RE: ACKNOWLEDGEMENT OF RECEIPT OF ADDENDUM NO. 3

ADDENDUM NUMBER 03

PROJECT: **MIB RENOVATIONS**
REID STATE TECHNICALCOMMUNITY COLLEGE
GMC PROJECT NO. ABHM250047

GRADING PLAN

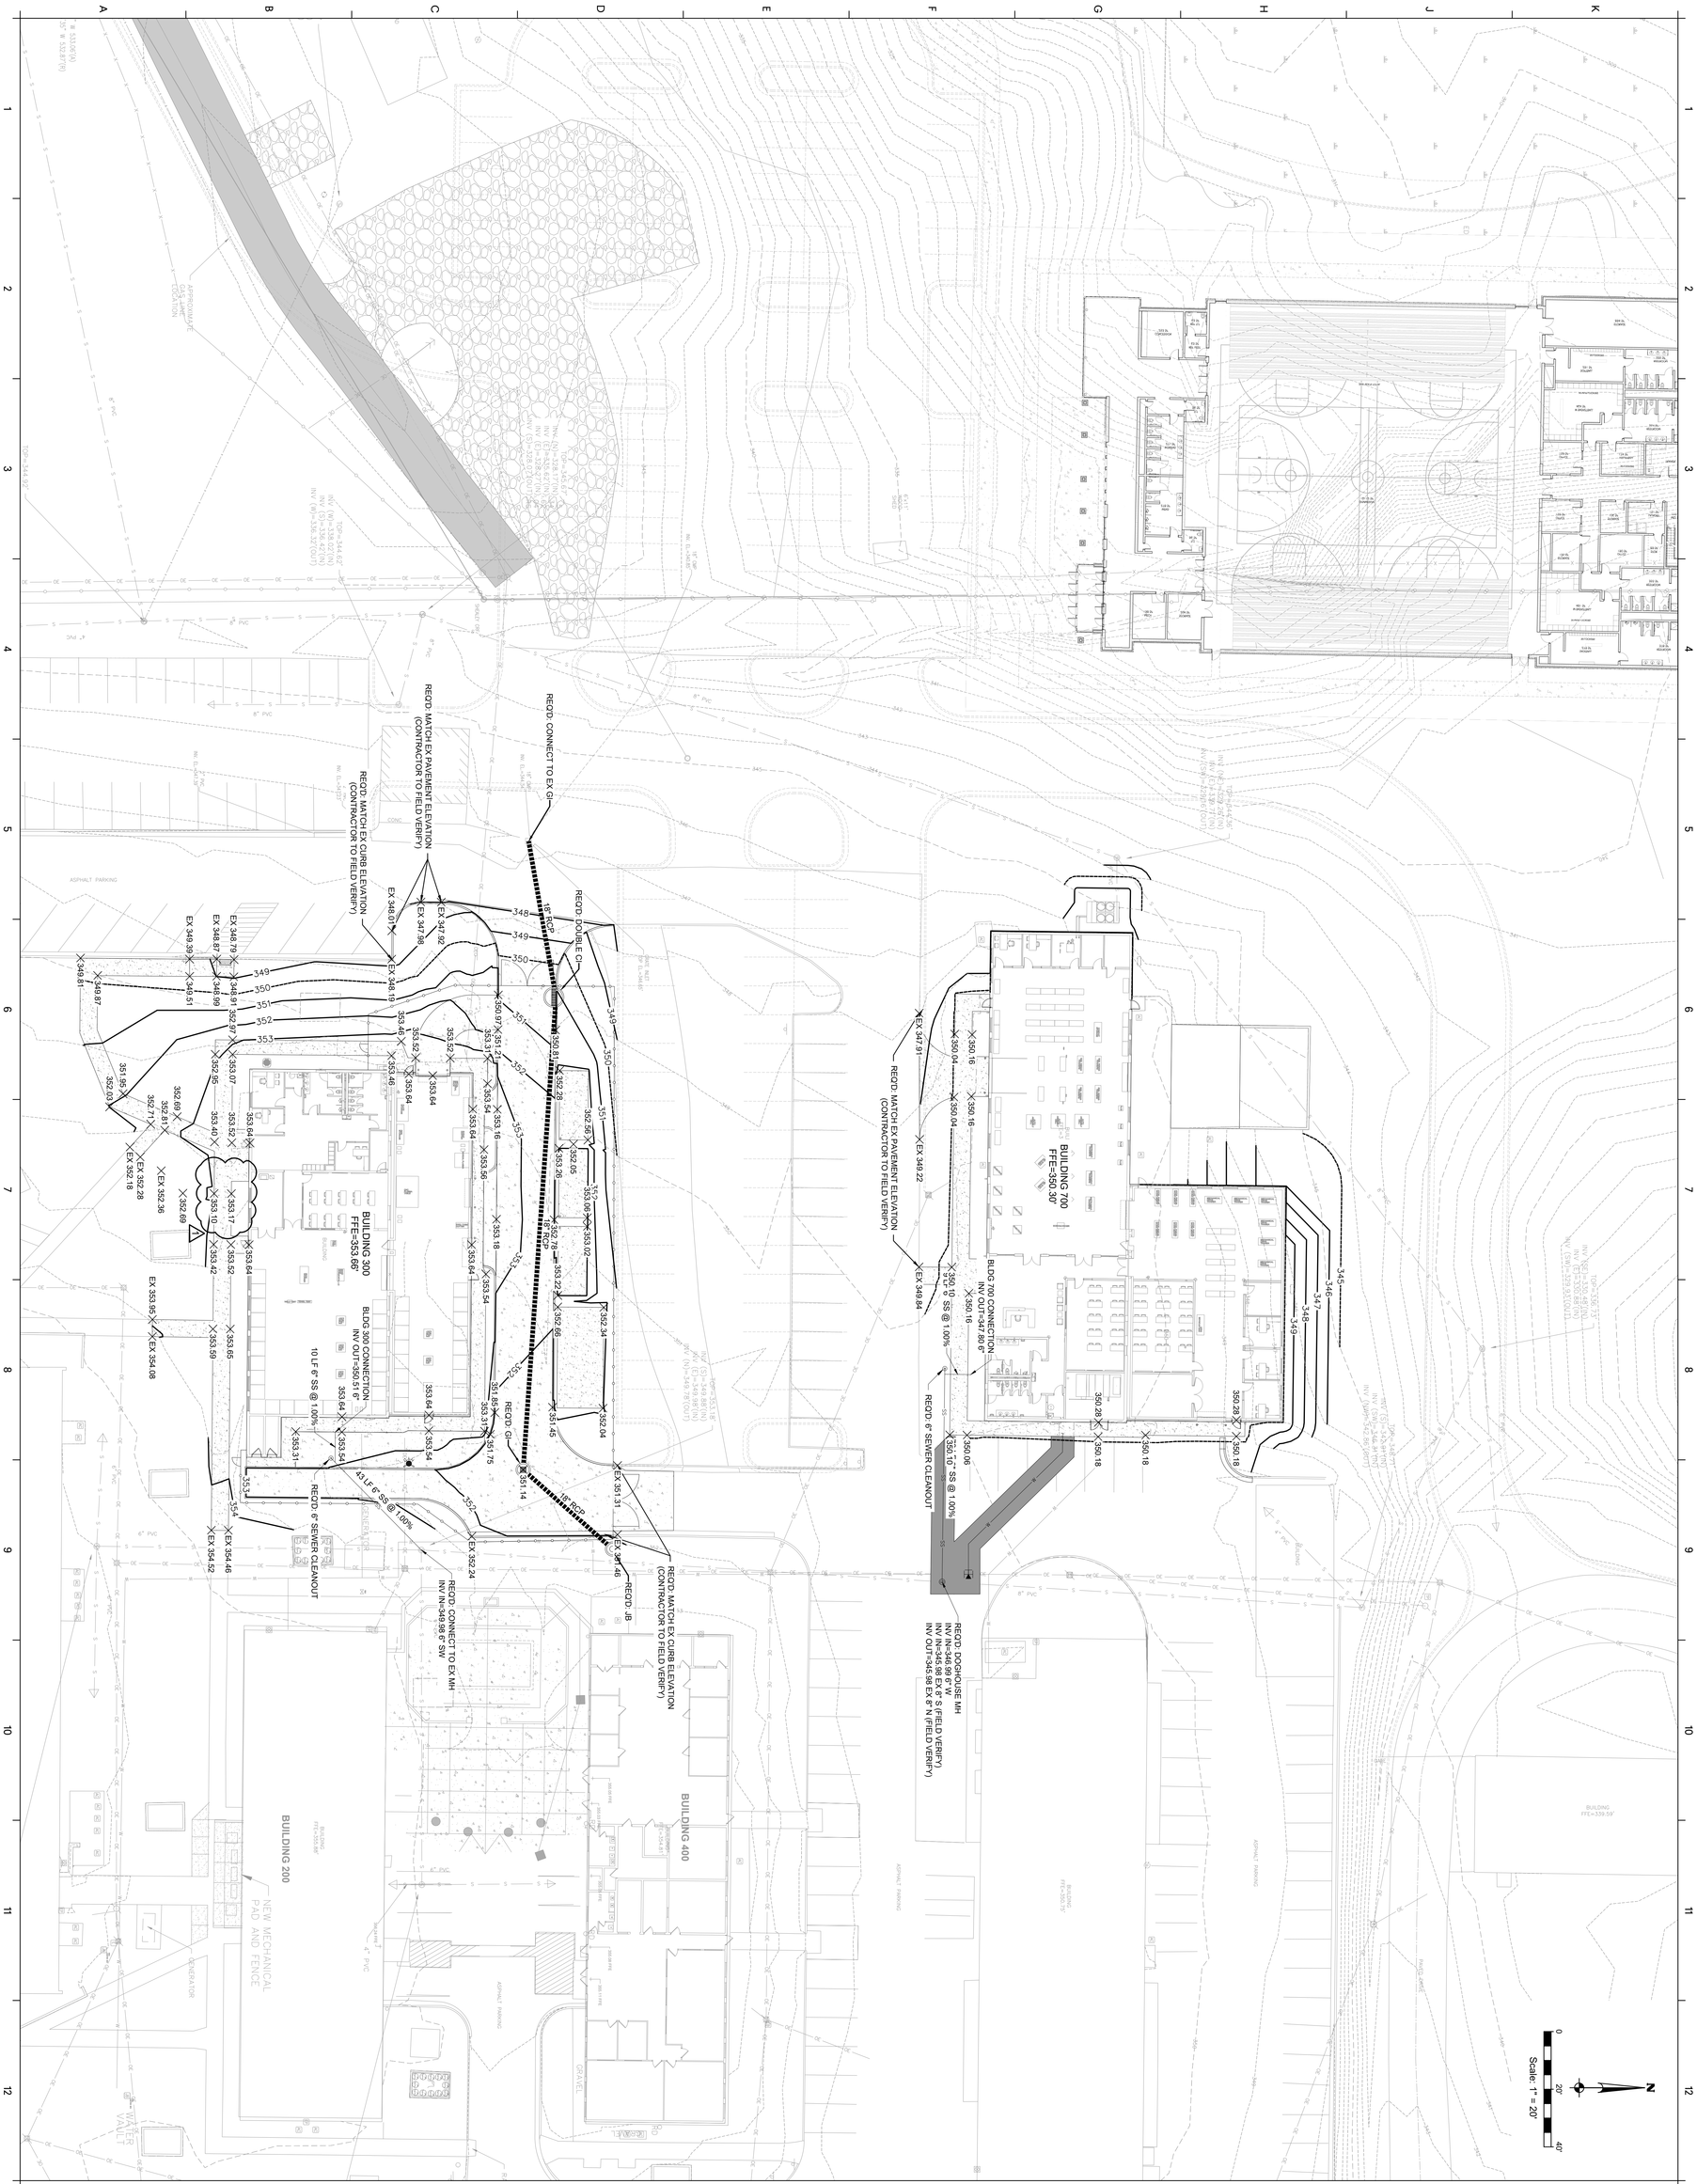
E. Reference Revised **Sheet C-201 – GRADING PLAN** and replace with attached revised document.
   i. Grading updated to accommodate expanded sidewalk at building 300.

UTILITY PLAN

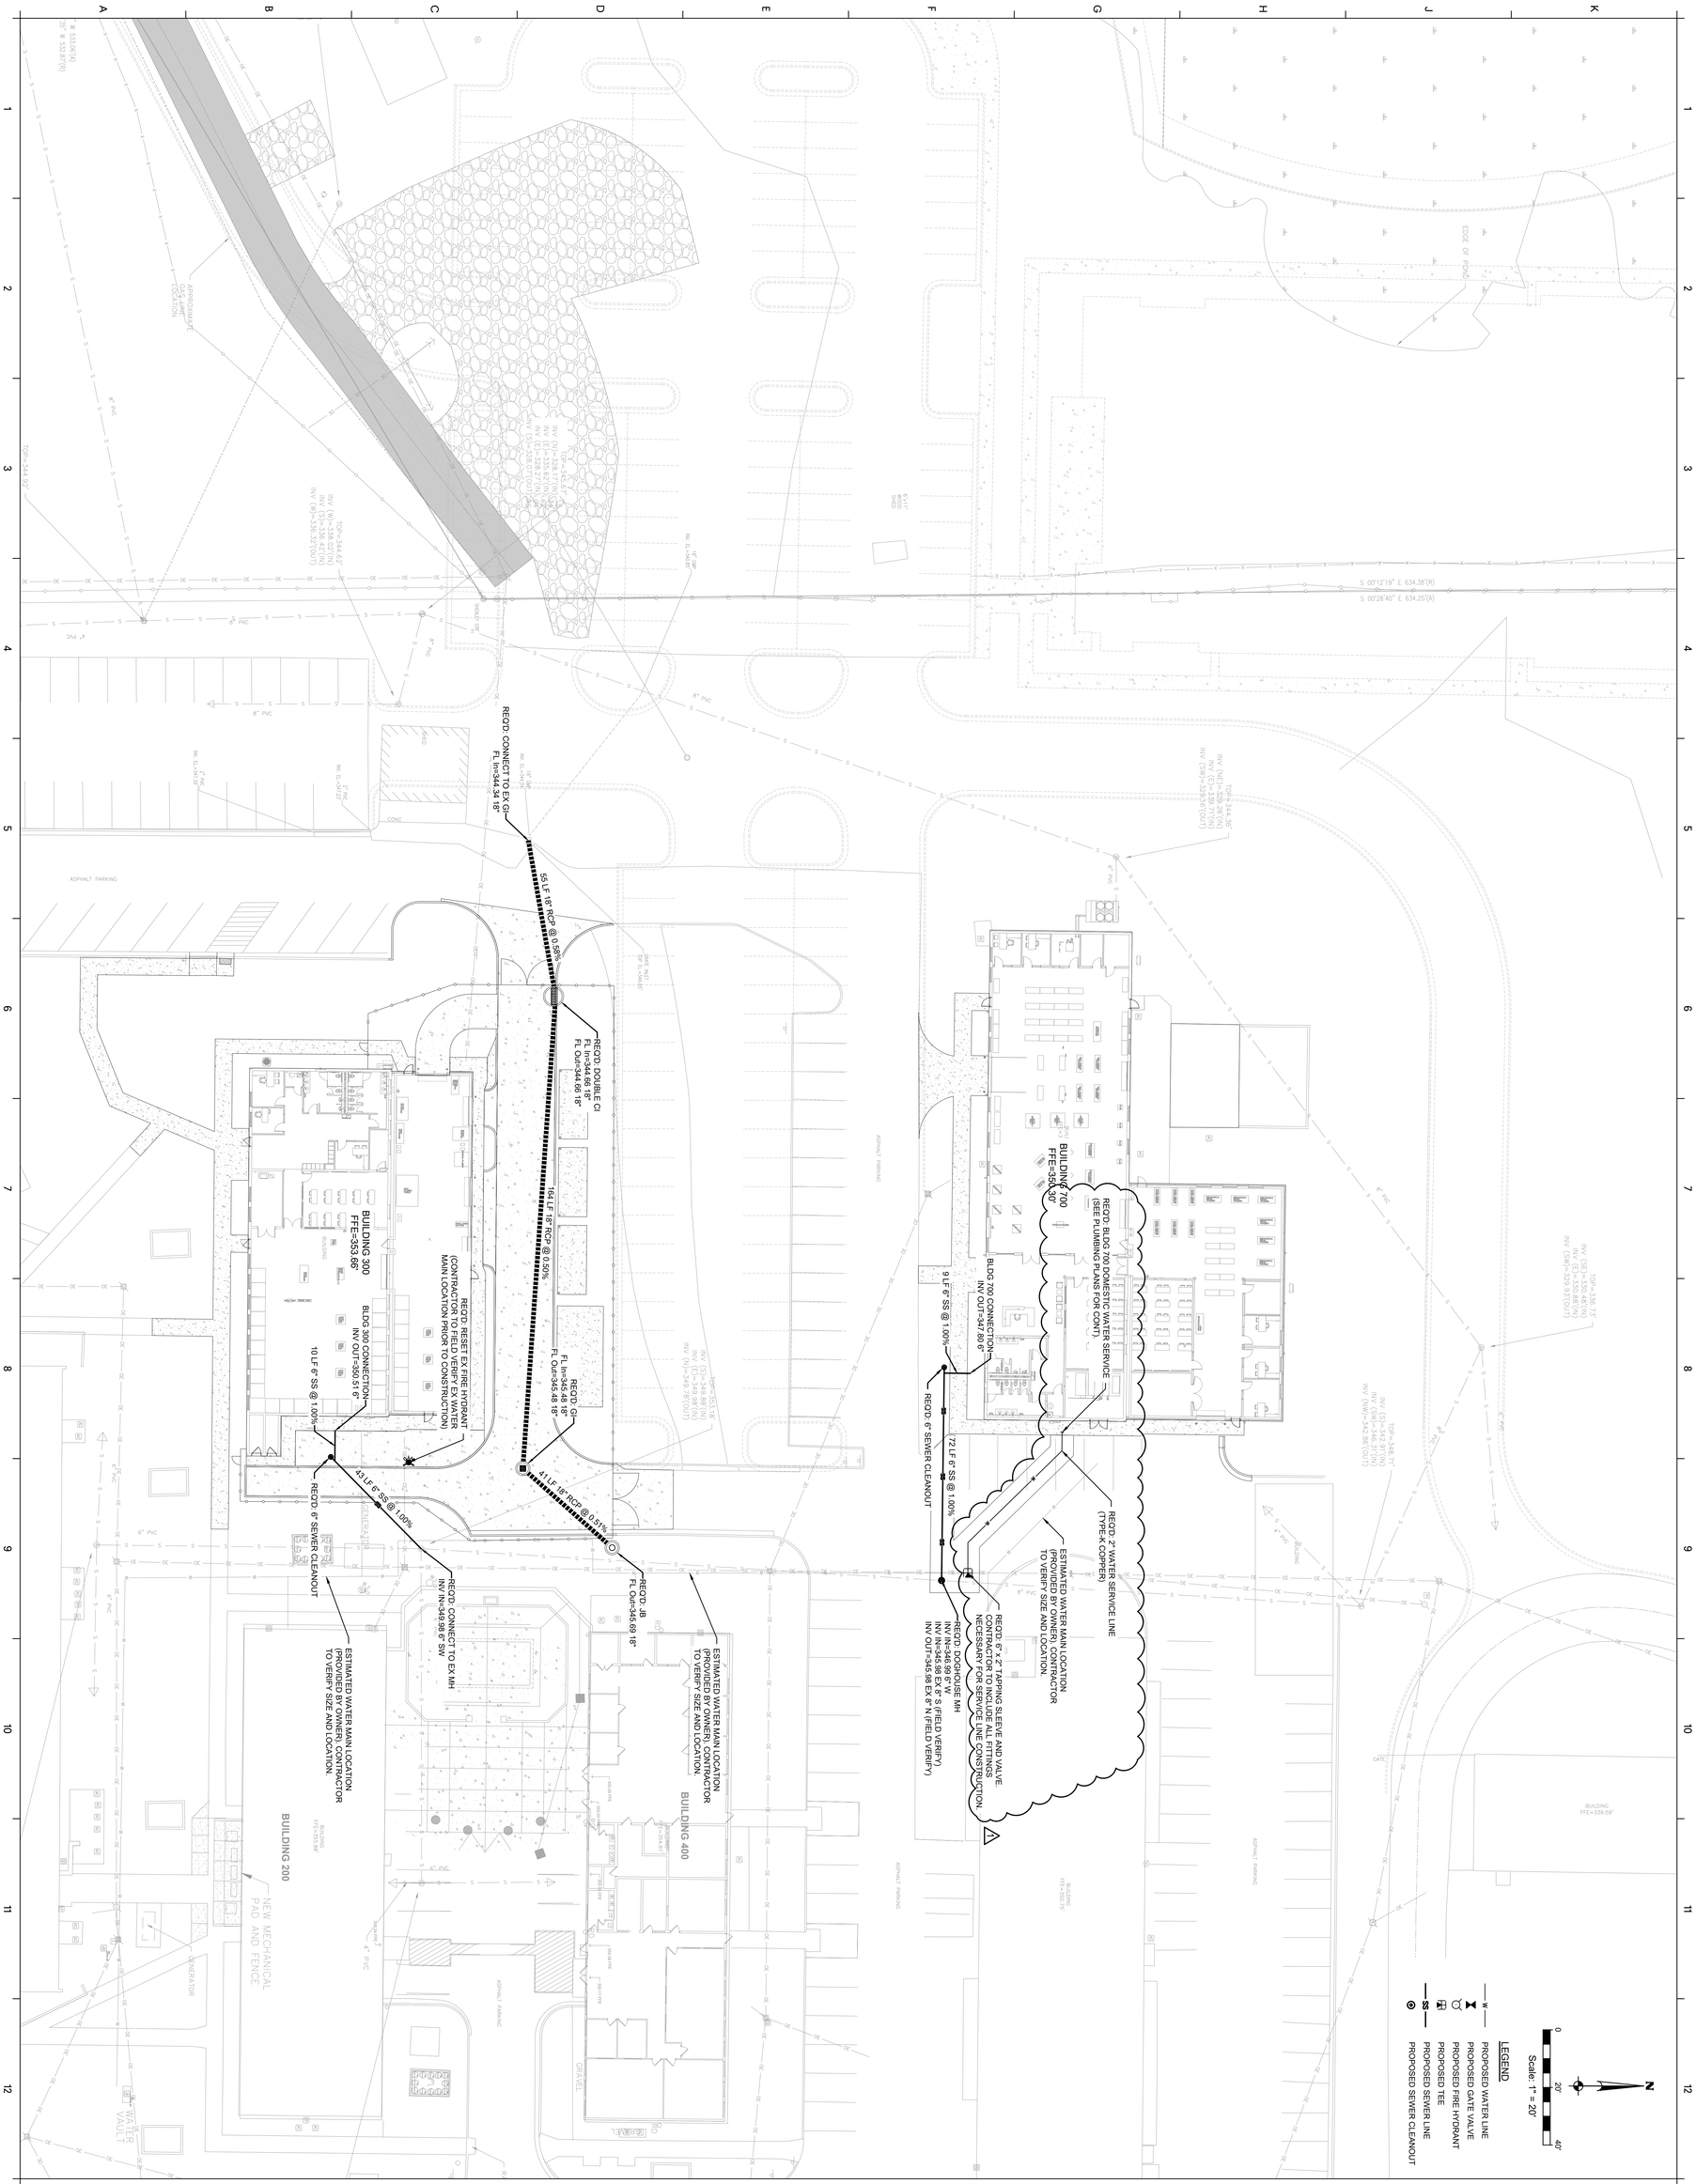
F. Reference Revised **Sheet C-301 – UTILITY PLAN** and replace with attached revised document.
   i. Added 2" water service to Building 700 and connection to existing water main.

PAVEMENT PATCH
NOT TO SCALE

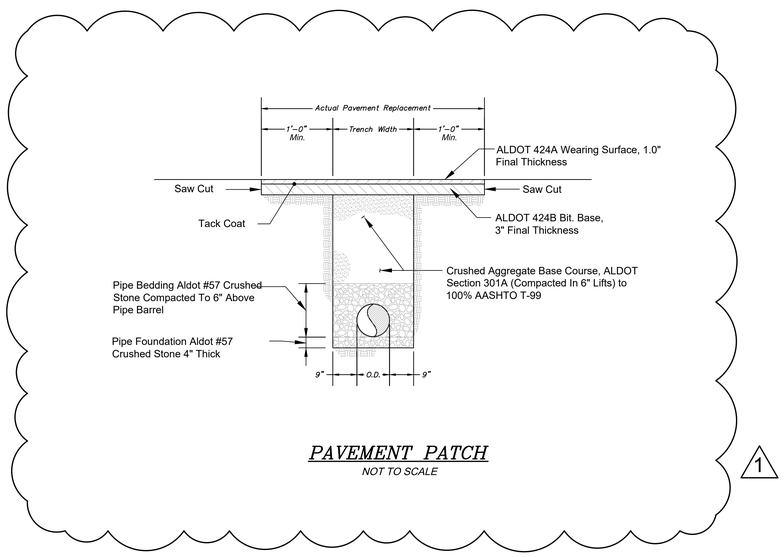
G. Reference Revised **Sheet C-903 – SITE DETAILS** and replace with attached revised document.
   i. Added pavement patch detail.

PIPE TRENCH DETAIL

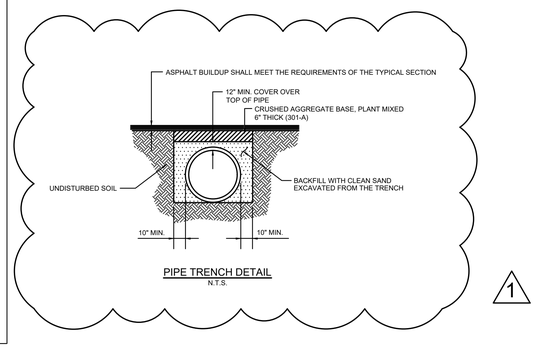
H. Reference Revised **Sheet C-904 – STORM DETAILS** and replace with attached revised document.
   i. Added pipe trench detail.

A1.01A

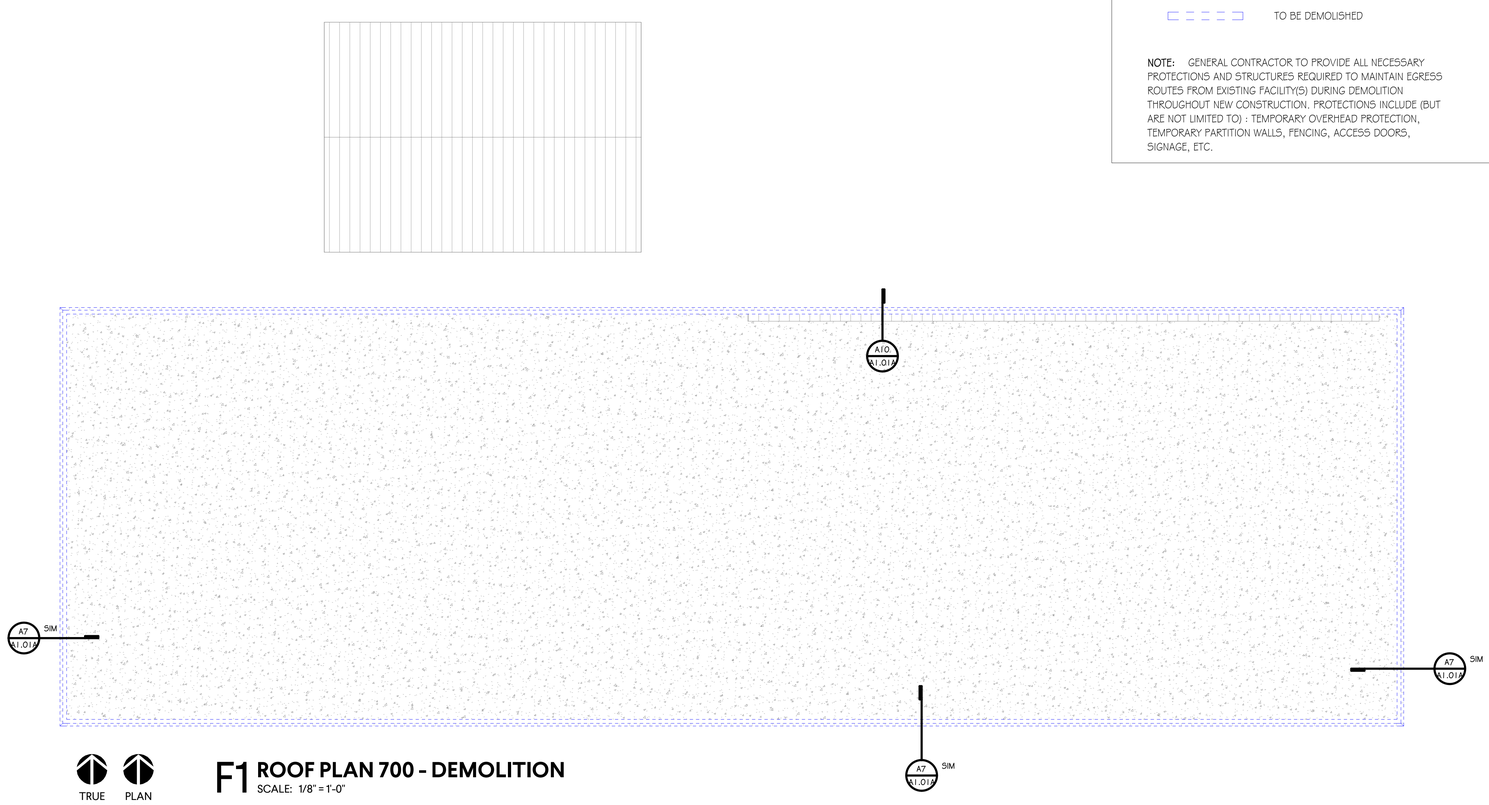
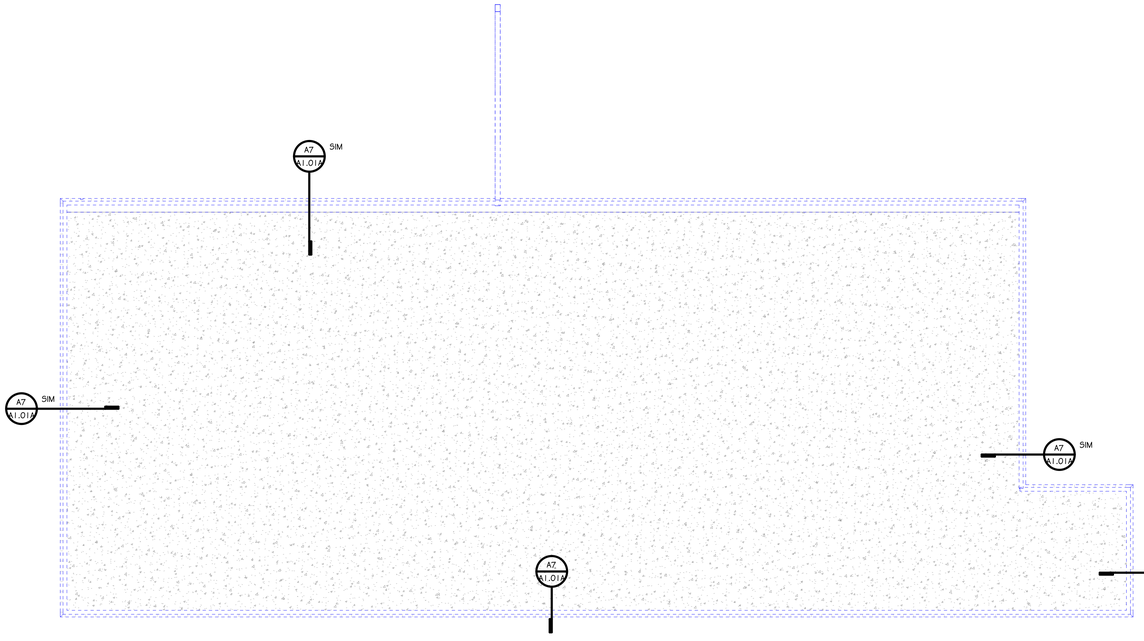
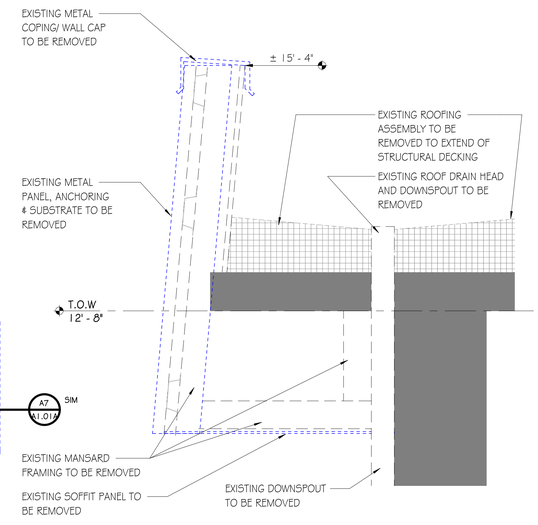
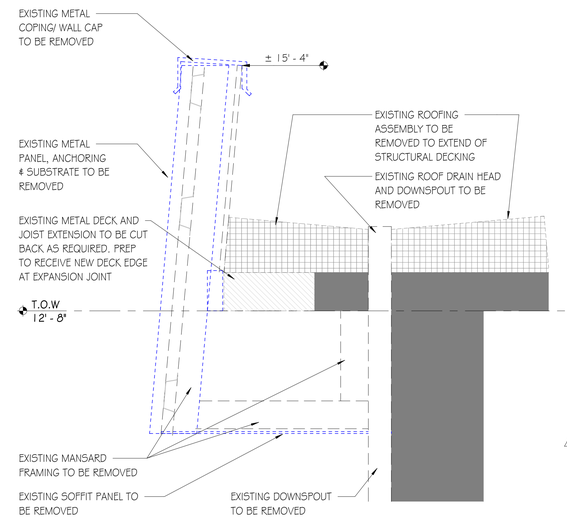
B. Reference NEW **Sheet A1.01A – DEMOLITION ROOF PLANS & DETAILS** and replace with attached revised sheet.
   i. Extent of mansard roof and soffit demolition defined. New details and demolition notes provided.
